CHESTERFIELD PLACE SUBDIVISION

APPLICATION NUMBER Holdover DATE December 7, 2006

SUBDIVISION PLAT

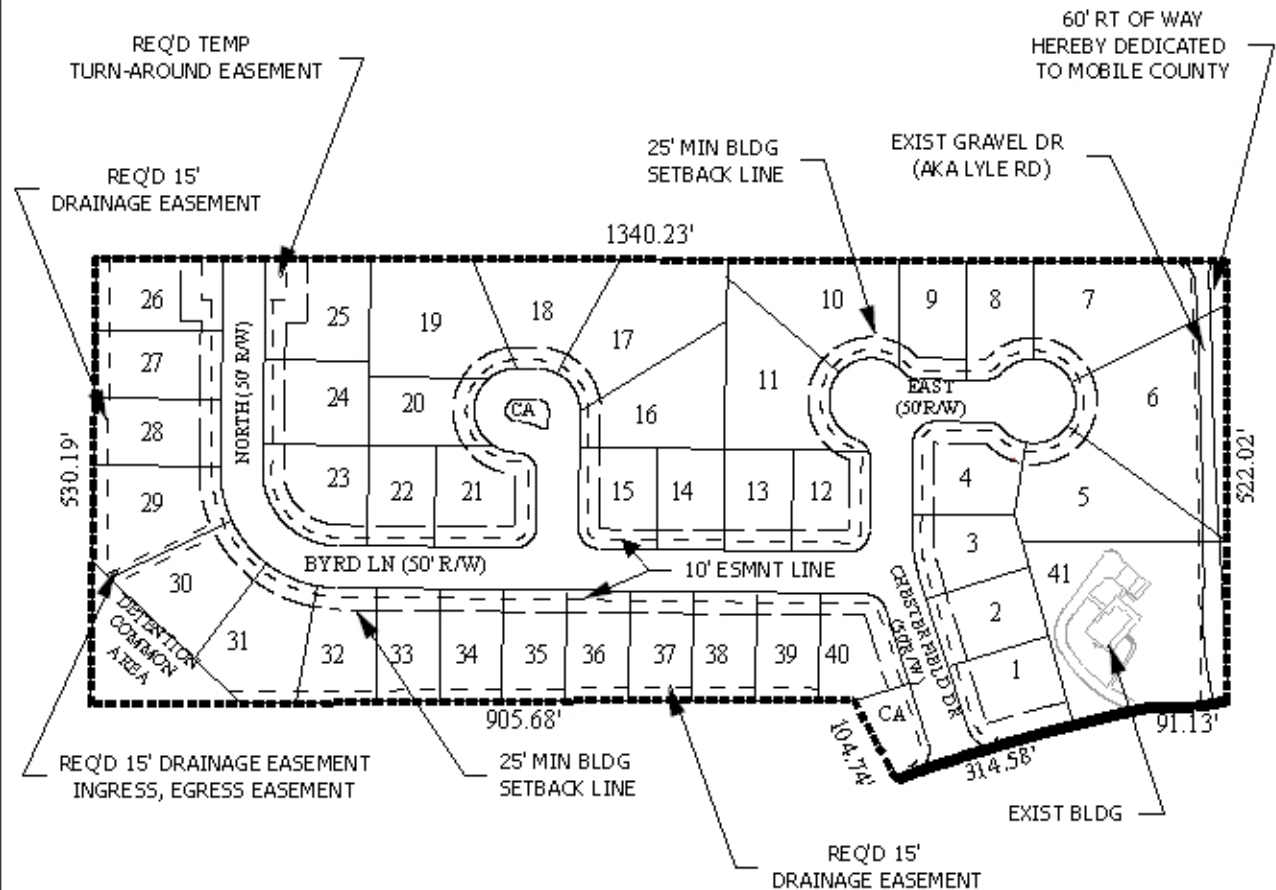
Wulff Road is a proposed major street, as illustrated on the Major Street Plan. The preliminary plat indicates Wulff Road has 80-foot right-of-way, however, the Major Street Plan requires that the right-of-way be 100 feet. Therefore, the dedication of right-of-way sufficient to provide 50-feet as measured from the centerline of Wulff Road, should be required.

Because Wulff Road is a proposed major street, access management is a concern. The development illustrates Lot 1 & Lot 41 with frontage on Wulff Road; therefore, Lot 1 should be denied access to Wulff Road and Lot 41 should be allowed one curb-cut to Wulff Road with the size, design and location to be approved by Mobile County Engineering Department. Additionally, as illustrated on the preliminary plat, a note should be placed on the Final Plat stating that Lots 4, 12, 15, 21, and 40; which are corner lots should be restricted to one curb-cut.

As illustrated and described on the preliminary plat, a gravel drive (Lyle Road) a 15-foot roadway easement is the traveled road to Travis Sellers Subdivision. This 3-lot subdivision was approved by the Commission in February 1997 subject to the condition of dedication of 15-foot along Lyle Road. However, the applicant could not dedicate property he did not own; therefore, the applicant dedicated 60-foot to the County along the portion of the gravel drive (Lyle Road) that fronts Travis Sellers Subdivision. This dedication of property to the County is adjacent to and would allow access for the future expansion from a street stub from Winston Drive (Churchill Downs, Second Unit). Therefore, the applicant of the proposed Chesterfield Place should dedicate sufficient right-of-way to provide 60-feet from the street stub from Winston Drive to the 60-foot dedication required by the County from the Travis Sellers Subdivision to allow further resubdivision of undeveloped property.

It appears that each lot meets the minimum size requirements for developments with access to public water and sewer. Due to the size of the proposed development, it is requested that the applicant revise the preliminary plat to provide the size of each lot in square feet on the plat, either as a table or as a label for each individual lot.

Common areas and detention areas are depicted on the preliminary plat. All common areas, whether green spaces, detention areas, or other, should be labeled as such, and a note should be placed on the final plat, if approved, stating that maintenance of all common areas shall be the responsibility of the subdivision's property owners.

Based on the preceding, it is recommended that application be held over to the December 7th meeting, to allow the applicant to revise the plan and illustrate the dedication of right-of-way from the street stub from Winston Drive to the right-of-way dedicated by the Travis Sellers subdivision. Revised materials, additional lot fees, mailing fees, and labels must be received in Urban Development by November 6th.

The plat meets the minimum requirements of the Subdivision Regulations and is recommended for Tentative Approval, subject to the following conditions: 1) dedication of sufficient right-of-way to provide 50 feet from the centerline of Wulff Ridge Road; 2) placement of a note on the Final Plat denying Lot 1 access onto Wulff Ridge Road and limiting Lot 41 to one curb-cut onto Wulff Ridge Road, with the size, design and location of all curb-cuts to be approved by the Mobile County Engineering Department; 3) the placement of a note on the Final Plat stating that Lots 4, 12, 15, 21, and 40; which are corner lots be restricted to one curb-cut; 4) provision of a certification letter from a licensed engineer to the Planning Section of Urban Development, certifying that the stormwater detention and drainage facilities comply with the City of Mobile stormwater and flood control ordinances, prior to the signing and recording of the final plat; 5) labeling of all lots with size in square feet, or provision of a table with the lot size information on the plat; 6) identification and labeling of all common areas, including greenspaces, and detention areas, and placement of a note on the plat stating that maintenance of all common areas shall be the responsibility of the subdivision's property owners; 7) placement of a note on the Final Plat stating that any lots which are developed commercially and adjoin residentially developed property must provide a buffer, in compliance with Section V.A.7. of the Subdivision Regulations.
